Contract #: 04-0120F4Cty: SF/ALA Rte: 80 PM: 13.2/13.9File #: 69.25B**QUALITY ASSURANCE -- NON-CONFORMANCE REPORT****Location:** Changxing Island, Shanghai, P.R. China**Report No:** NCR-000672**Prime Contractor:** American Bridge/Fluor Enterprises, a JV**Date:** 03-Feb-2010**Submitting Contractor:** Zhenhua Port Machinery Company, Ltd (ZPMC), Changxing Island**NCR #:** ZPMC-0640**Type of problem:**

Reference Description: Missed MT and UT indications by QC on welded members in Segment 9AE**Description of Non-Conformance:**

Dear: Mr. Charles Kanapicki
Attention: Mr. Thomas Nilsson Project/Fabrication Manager
Subject: NCR No. ZPMC-0640

Job Name: SAS Superstructure
Document No: 05.03.06-000631

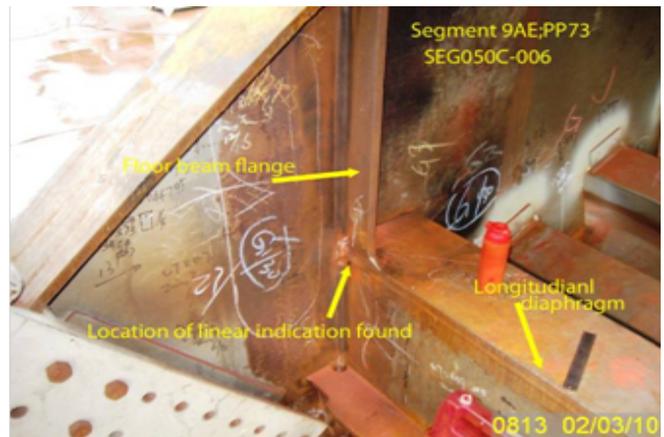
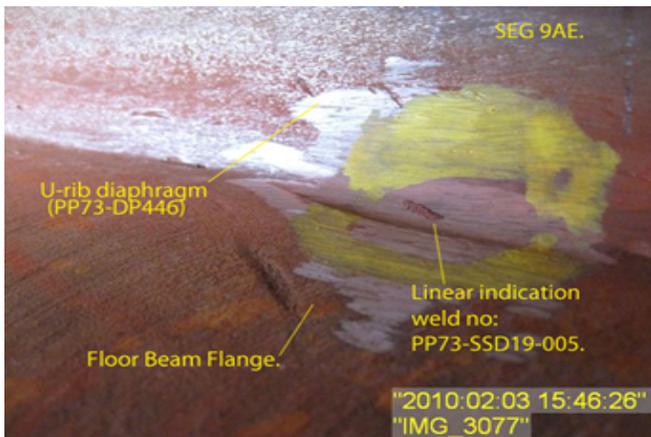
- Location #1: Two (2) longitudinal Class "A" indications.
- Indication #1 measures approximately 15mm.
- The indication dBs rating is +6.
- Material thickness is 20mm.
- The depth of the indication is approximately 16.5mm.
- The weld is identified as SSD19A-PP72-134.
- The indication is clearly marked on or near the weld.
- The Y location is approximately 70mm from edge of the flange plate.
- The weld is a Complete Joint Penetration (CJP) Butt joint joining Flange Plate X5D-2 to Floor Beam X5D.

- Location #2: One Indication measures approximately 12mm.
- The indication dBs rating is +7.
- Material thickness is 20mm.
- The depth of the indication is approximately 17mm.
- The weld is identified as SSD19A-PP73-128.
- The indication is clearly marked on or near the weld.
- The Y location is approximately 55mm from edge of the flange plate.
- The weld is a Complete Joint Penetration (CJP) "T" joint joining Flange Plate X5D-2 to Floor Beam X7L.
- These indications (location #1 and #2) are located in an area previously tested and accepted by ZPMC Quality Control (QC) personnel. As per the contract documents, ZPMCs QC personnel are required to perform 25% UT inspection of this weld.

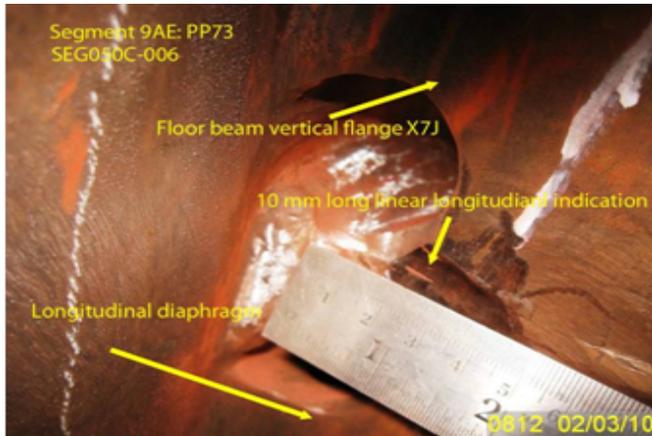
- One (1) longitudinal linear crack that measured approximately 10mm in length.
 - The weld is identified as SEG050C-006 at panel point (PP) 73.
 - This weld is a partial joint penetration (PJP) weld joining the Floor Beam (FB10A) to the vertical Flange (X7J) that attaches to the Longitudinal Diaphragm (LD2A).

- The weld is identified as SSD19-PP73-005.
 - The weld is an 8mm fillet T-joint joining the deck panel diaphragm to the top flange of the FL2-1 floor beam at PP 73.

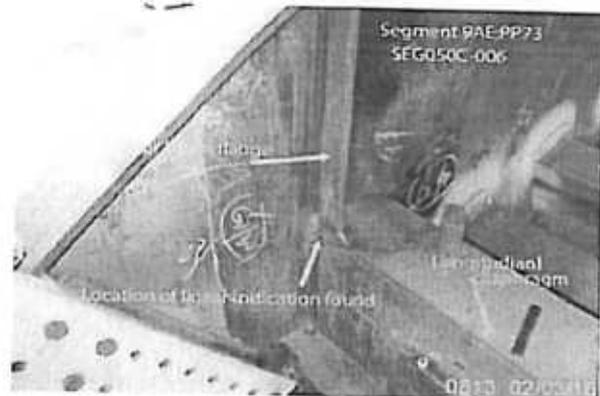
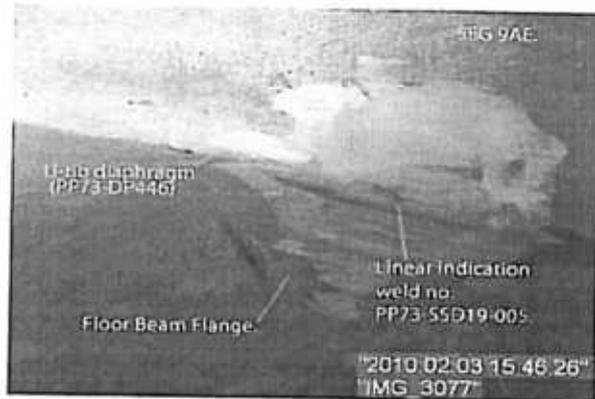
- Location #1: Two (2) longitudinal Class "A" indications.
- Indication #1 measures approximately 15mm.
- The indication dBs rating is +6.
- Material thickness is 20mm.

- The depth of the indication is approximately 16.5mm.
- The weld is identified as SSD19A-PP72-134.
- The indication is clearly marked on or near the weld.

- The Y location is approximately 70mm from edge of the flange plate.
- The weld is a Complete Joint Penetration (CJP) Butt joint joining Flange Plate X5D-2 to Floor Beam X5D.

- Location #2: One Indication measures approximately 12mm.
- The indication dBs rating is +7.
- Material thickness is 20mm.
- The depth of the indication is approximately 17mm.

- The weld is identified as SSD19A-PP73-128.
- The indication is clearly marked on or near the weld.
- The Y location is approximately 55mm from edge of the flange plate.

- The weld is a Complete Joint Penetration (CJP) "T" joint joining Flange Plate X5D-2 to Floor Beam X7L.
- These indications (location #1 and #2) are located in an area previously tested and accepted by ZPMC Quality Control (QC) personnel. As per the contract documents, ZPMCs QC personnel are required to perform 25% UT inspection of this weld.

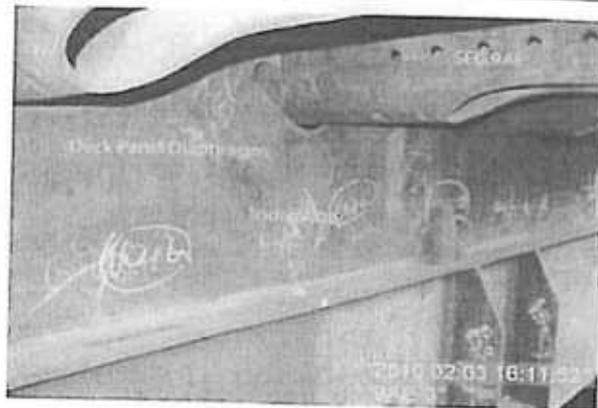
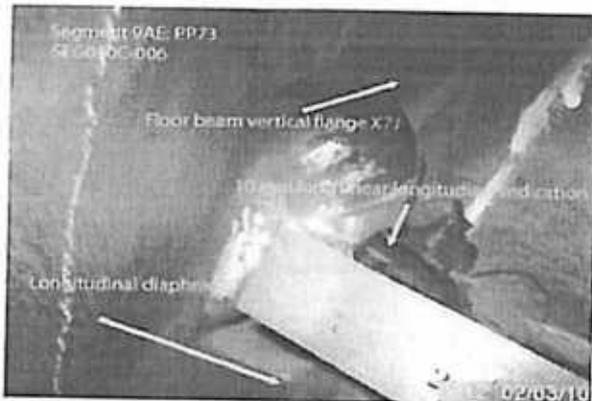
- One (1) longitudinal linear crack that measured approximately 10mm in length.
 - The weld is identified as SEG050C-006 at panel point (PP) 73.
 - This weld is a partial joint penetration (PJP) weld joining the Floor Beam (FB10A) to the vertical Flange (X7J) that attaches to the Longitudinal Diaphragm (LD2A).

- The weld is identified as SSD19-PP73-005.
 - The weld is an 8mm fillet T-joint joining the deck panel diaphragm to the top flange of the FL2-1 floor beam at PP 73.

- The Y location is approximately 9800mm from the bike path end of this floor beam.
 - The indication is clearly marked on the material on/near the weld.
-

WELD NUMBER: SSD19A-PP072-134

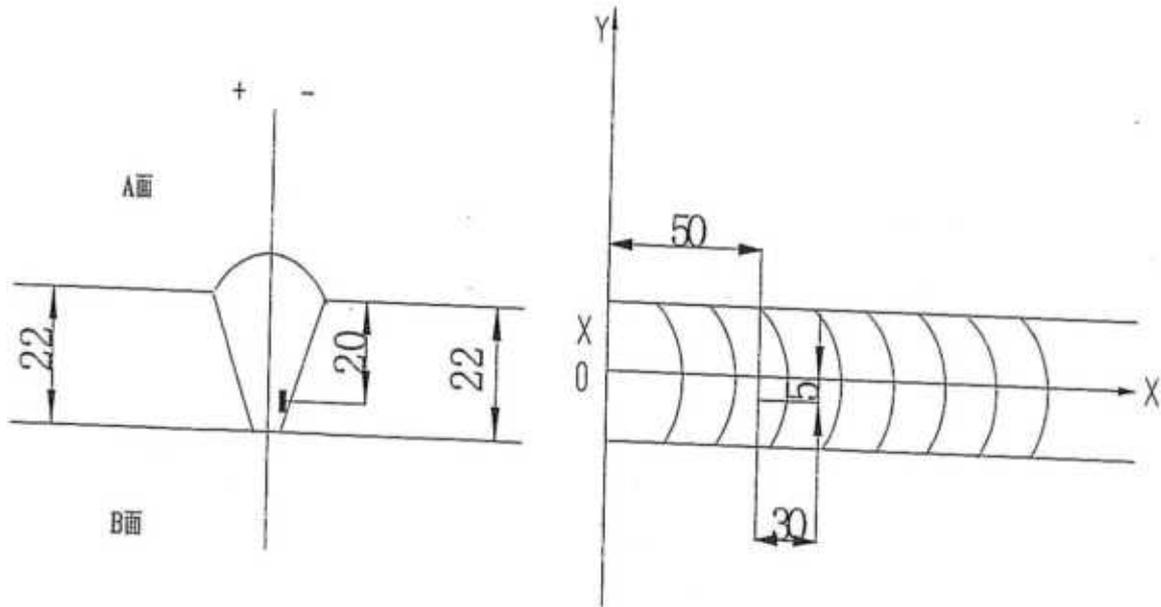
Rejected indication found by ultrasonic inspection is less than the maximum allowance aggregate length.

1. Gouge or grind from nearer side from metal edge ($D \leq 0.65T$, "D" is depth of defects, "T" is thickness of metal) to remove all defects;

2. Follow repair WPS for joint preparation, preheat, and weld deposit;

3. Verify with VT no defects remain in the weld joint prior to welding;

4. Grind the repaired area flush with base metal or the adjacent weld;

5. Perform UT inspection to the weld along with 50mm on each end of the repair area;

WELD NUMBER: SSD19A-PP073-128

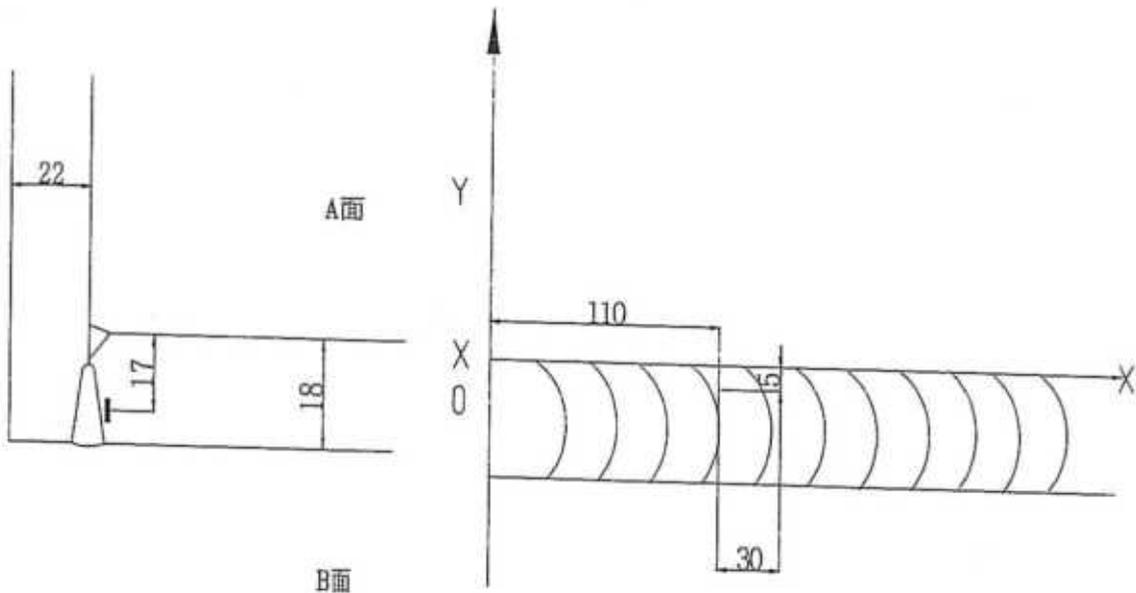
Rejected indication found by ultrasonic inspection is less than the maximum allowance aggregate length.

1. 从缺陷距离端面较近一侧 ($D \leq 0.65T$, D为缺陷深度, T为板厚) 采用碳刨或打磨的方法去除焊缝缺陷;
 2. 参照返修焊接工艺规程 (WPS) 准备正确的接头型式, 预热和焊接;
 3. 焊前对修补区域进行VT检测保证缺陷完全被清除;
 4. 将修补区域打磨到与母材或邻近焊缝平齐;
 5. 对焊缝进行UT检测, 检测范围为返修区域以及其两端各延长50mm.
-
1. Gouge or grind from nearer side from metal edge ($D \leq 0.65T$, "D" is depth of defects, "T" is thickness of metal) to remove all defects;
 2. Follow repair WPS for joint preparation, preheat, and weld deposit;
 3. Verify with VT no defects remain in the weld joint prior to welding;
 4. Grind the repaired area flush with base metal or the adjacent weld;
 5. Perform UT inspection to the weld along with 50mm on each end of the repair area;

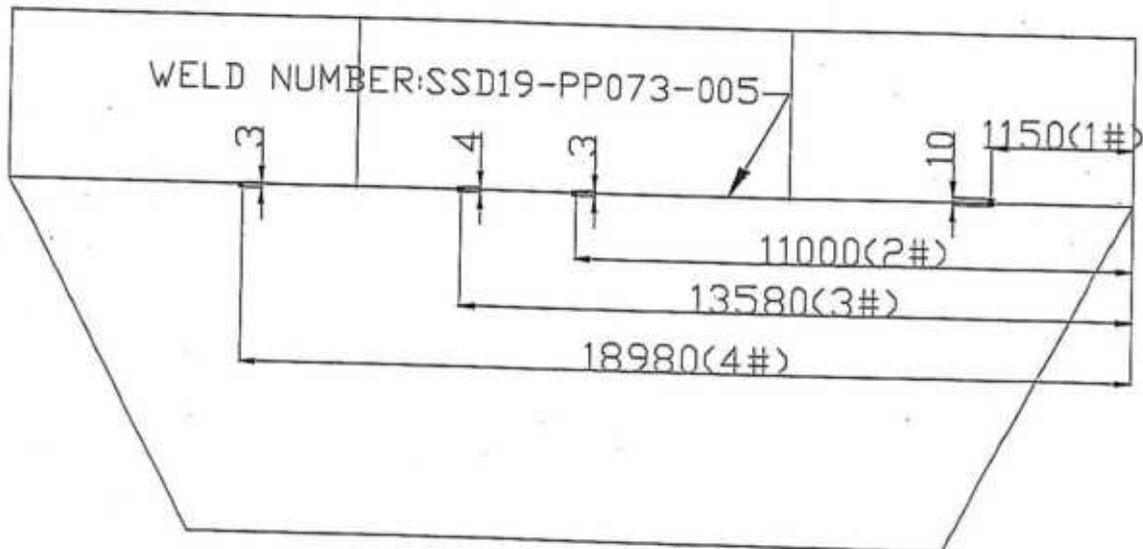
Four transverse cracks were found by use of MT on SSD19-PP073-005.

2. QC and a Lead CWI shall have an approved copy of the CWR in hand prior to the repair.
3. Remove paint ≥ 25 mm in all direction of HAZ prior to MT.
4. Clean the excavation area of all loose debris including MT powder. Preheat to 65° C before removing cracks by grinding, repair area shall extend a minimum of 50mm beyond each end of single crack repairs and 50mm beyond the outermost cracks for multiple crack repairs.

6. Prepare excavation in accordance with the New Repair Procedure prior to welding.
7. Before this repair, Verify with VT and MT repair areas are defects free, and also MT shall be performed on the base metal laying abroad cracks to ensure that no cracks were propagated to the base metal. Separate CWR approval is needed if cracks are found in the base metal, and only after this new CWR's approval can continue the repair.

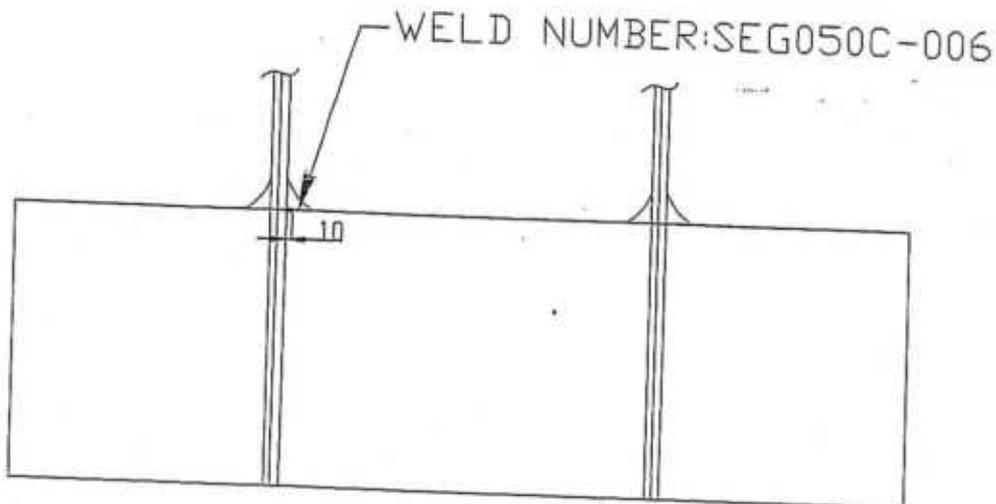
One longitudinal crack was found by use of MT on SEG050C-006

2. QC and a Lead CWI shall have an approved copy of the CWR in hand prior to the repair.
3. Remove paint ≥25mm in all direction of HAZ prior to MT.
4. Clean the excavation area of all loose debris including MT powder. Preheat to 65° C before removing cracks by grinding and it applied to all the repair process. Repair area shall extend a minimum of 50mm beyond each end of single crack repairs.

7. Before this repair, Verify with VT and MT repair areas are defects free, and also MT shall be performed on the base metal laying abroad cracks to ensure that no cracks were propagated to the base metal. Separate CWI approval is needed if cracks are found in the base metal, and only after this new CWR's approval can continue the repair.
